ARBORIST REPORT

**PROPOSED INDUSTRIAL WAREHOUSE
4385 MAINWAY
CITY OF BURLINGTON**

Revised as per City Forestry Comments – August 2, 2022

RESPONSE MATRIX
4385 Mainway, Burlington
File No: 535-010/21
Date: April 4, 2022

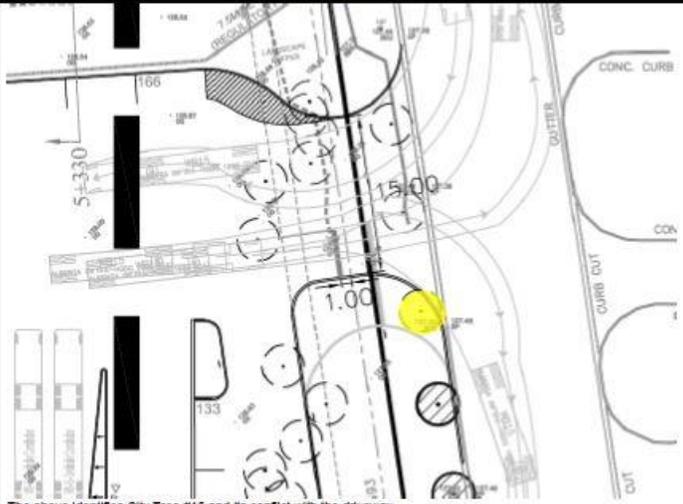
ITEM	COMMENT	RESPONSE
15	The photometrics plan identified lighting. Where are the fixtures located? Provide catalogue cuts for the fixtures.	Please refer to the updated photometrics plan that identifies multiple wallpacks lighting fixtures affixed to the building façade, as well as 1 light standard. Please also refer to the Luminaire Detail Plan and cut sheets for greater details. In addition, the elevation and site plan drawings identify the wallpack locations and single light standard. We understand this item can be cleared.
16	Is a pylon sign being proposed?	Signage is not being shown on the site plan at this time.
17	Is the proposed snow storage area large enough to accommodate the entire site?	In times of heavy precipitation, excess snow removal will be provided through a private snow removal service in addition to the proposed dedicated areas for on-site snow storage. Please refer to the site plan drawing for the snow storage area, including a note regarding how the snow removal will be handled privately with a future contractor. We understand this item can be cleared.

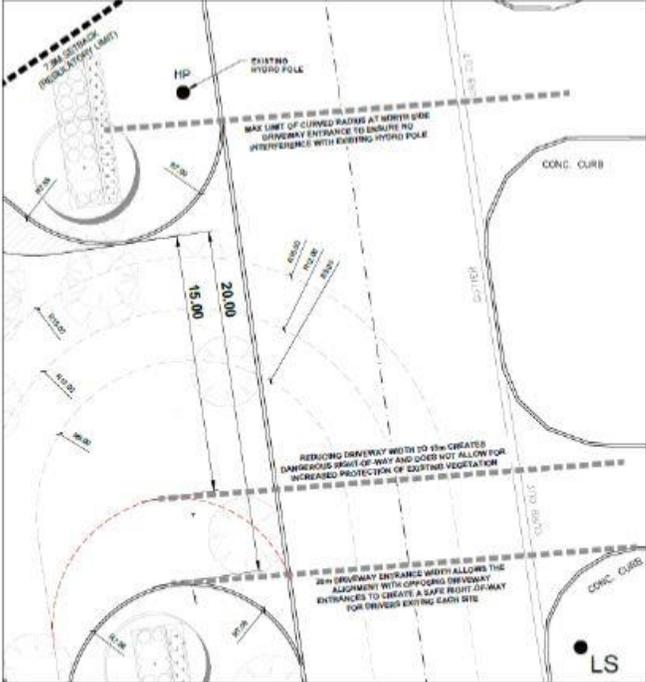
18	The North-East driveway entrance is very wide. Per OPSD 350.010, assuming Heavy Industrial, the appropriate widths are 9.0m - 15.0m for two-way traffic.	As discussed with Forestry and Planning Departments on March 11, since the last submission was made, Menkes has had to demonstrate an additional 7.5m regulatory limit on all plans to address Conservation Halton's (CH) comments. Within this regulatory area, development/structures aren't permitted. As a result, the drive aisle and associated parking that was once located on the northern limits of the site has been removed to accommodate the additional 7.5m setback. In light of this revision, the only entrance/exit for trucks to utilize is from Mainway. Our design team has reviewed the City's suggestion to reduce the driveway from 20m to 15m in hopes of retaining 1 City tree and potentially a private tree. From a landscape perspective, with introducing the additional 7.5 regulatory area per CH's comments, the driveway has naturally had to shift further south in order to accommodate this new setback. As a such, 3 municipal trees (and various private trees) are unfortunately still required for removal. In an effort to reduce the driveway to 15m to save the 3 rd City Tree (tree #16), the arborist has reviewed this revision and per the enclosed sketch (below), Tree #16 tree would not be able to be preserved as the tree protection zone wouldn't be able to properly shield the tree due to the future driveway/curb cut. In addition to this, our arborist has revisited the site on March 29 th and found that the City trees in question were no mature nor where they in great condition. As such, our proposal seeks to improve and upgrade the streetscape within proximity to the site and municipal ROW. Separate from this, the proposal includes the planting of 70 new trees, which exceeds the compensation requirement. We trust this can sufficiently address the removal of the private trees within the site limits. Please refer to the response memo prepared by Strybos Barron King Landscape Architecture dated April 1, 2022. Pleas also refer to the "Discussions" Section and related photos, and the "Calculation of Tree Removal Compensation" section within the Arborist Report, all of which speak to this driveway review.

ITEM	COMMENT	RESPONSE
		 <p>The above identifies City Tree #16 and its conflict with the driveway</p> <p>In addition to above, our architect has also reviewed the potential reduction to 15m and had tried to shift the driveway north to accommodate City Tree #16. However, in doing so, the driveway will a) no longer be aligned with the adjacent 3 driveways which was a request made by Transportation Services to ensure the driveways properly aligned; b) this will create an encroachment (i.e. radius) into the 7.5m regulatory area, which is not permitted by CH; and, c) this will create a conflict with the exiting utilities to the north as the radius for this driveway, which is needed to accommodate the only entrance/exit for truck traffic within this site, would interfere with the Hydro Pole. Please refer to the detail below, which is identified as Detail #2 on the site plan drawing</p>

ITEM	COMMENT	RESPONSE
		 <p>Having said the above, the driveway width is continuing to be designed to 20m. We trust this analysis by our retained design consultants is sufficient to identify the obstacles and resolution for this matter.</p>
